REVISION 2 STAFF REPORT 05-14-2025 REGULAR MEETING PREPARED BY: G. LANDSBERG
APPLICATION NUMBER: HDC2025-00243
ADDRESS: 1395 ANTIETAM, 1 LAFAYETTE PLAISANCE, 1301 NICOLET PLACE, 1300 NICOLET PLACE, 1301 JOLIET PLACE, 1300 JOLIET PLACE, AND ADJACENT RIGHTS-OF-WAY
HISTORIC DISTRICT: LAFAYETTE PARK/MIES VAN DER ROHE
APPLICANT: DETROIT THERMAL
ENGINEER: GIFFELS WEBSTER
OWNER OF RECORD: MULTIPLE (PRIVATE)
DATES OF STAFF SITE VISITS: 04-28-2025, 05-09-2025

SCOPE: EXCAVATE FOR EXISTING STEAM PIPE SLIPLINING AND NEW STEAM PIPE INSTALLATION, INSTALL CONSTRUCTION FENCING/TREE PROTECTION, RESTORE CONCRETE CURBS/LANDSCAPE/PAVEMENT, INSTALL PERMANENT STEAM STACKS (WORK STARTED WITHOUT APPROVAL)*

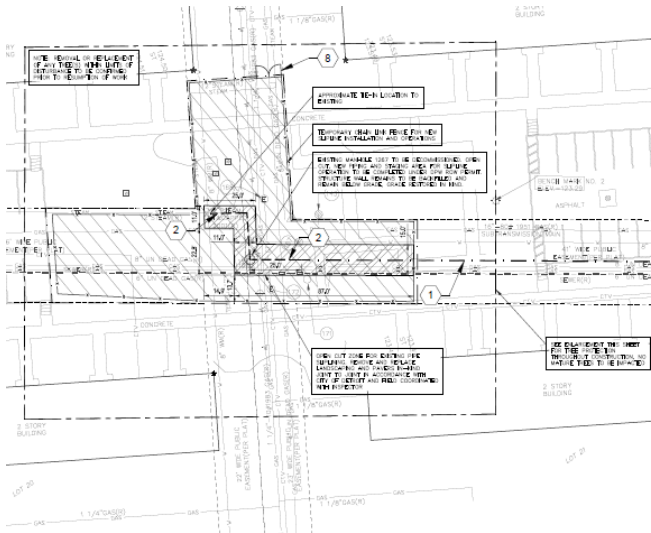
2 – Joliet Place vicinity, from applicant documents (not to scale). This location will feature a steam stack, located at the black triangle marked with key note 7 and highlighted by the red arrow. Staff photo, May 9, 2025. This work appears to have started but not completed. A small excavator is on site.

- Concerning the two steam stacks, staff notes that they are now proposed adjacent to parking areas terminating Nicolet and Joliet Place. It is noted that separation of the residential uses from the "mechanical" intrusions of cars and streets (and their associated visual impact) was (and is) a key feature of this resource. These parking areas already incorporate minor infrastructural elements including parking gate activators and bollards. According to the engineer, steam stacks built to current standards emit steam only rarely as they do not operate under the same conditions found elsewhere (e.g., along downtown streets), and are not a heat hazard. If the Commission decides that the steam stack impact is minor *in the context of the parking areas*, staff suggests that more study may yield an acceptable hidden location in the landscape immediately adjacent to these parking areas.

3 – “Old Maccomb” vicinity, from applicant documents (not to scale). Staff photo, May 9, 2025. This work is adjacent to the playground. Some ground disturbance activities and damage to specimen shrubs have been observed.

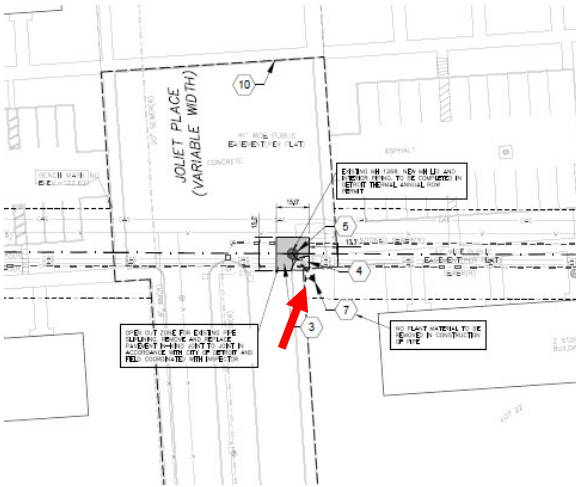
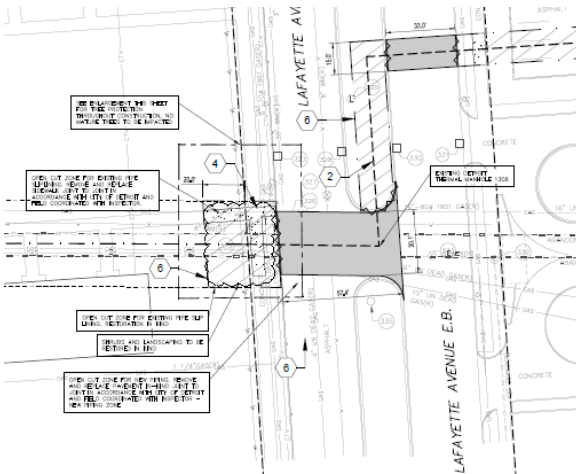
- The proposed work describes large areas of disturbance and excavation covering substantial portions of the mature landscape, especially at the Old Macomb ("playground") location. This vicinity holds a large and well-developed collection of mature woody plants, including at least twelve (12) honey locust trees approaching 80 years in age (i.e., original to the Mies/Caldwell plan), and smaller tree/shrub species including cotoneaster, yew, oakleaf hydrangea, redbud, viburnum, dogwood, and white spruce. Additional ground covers and perennial beds hosting pachysandra, hosta, ferns, and flowering bulbs were observed.

While above-grade tree protection is proposed for the larger honey locust trees, there is no apparent restriction on excavation or compaction within their drip zone/root zone, which may threaten tree survival. The ornamental trees and shrubs described above are decades old and have reached a mature size so that they contribute to a unified mature landscape, adding their shade and beauty to the overall protected composition.

- Staff has observed severe damage to at least one yew and a nearby magnolia at the Old Macomb location, which was reportedly caused by initial survey efforts on site by the applicant's crew or contractors. It is not clear from the application materials if the proposed work anticipates a similar degree of damage, or if greater protection measures are proposed for these smaller but historically important contributing landscape elements. Tree protection measures are indicated in an enlarged plan contained in the drawing set, excerpted below:

View to the east at the playground, taken from within the proposed excavation area (marked by red tape). Note that the vintage and original playground equipment is within the area of disturbance/work area delineated by the yellow tape. Staff photo, May 9, 2025.

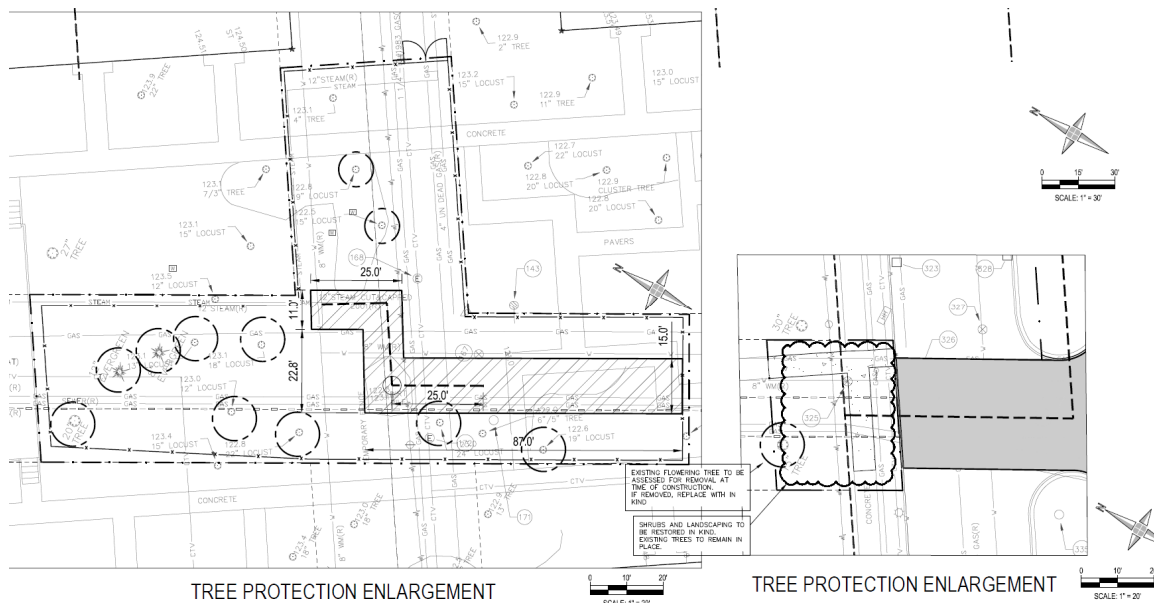
- ***Impact on other site elements, including playground, benches, and fence.*** The proposed work also impacts the playground at the heart of the townhouse development, which still consists of historic-age playground equipment and brutalist concrete benches of stark modern design that also contribute to the protected historic character of the district. Even the temporary removal of these features may cause them be damaged or lost, necessitating expensive and custom restoration of these elements. Contemporary replacement playground equipment and benches would look absurd in this formal and masterfully designed mid-century context, and would be highly inappropriate.
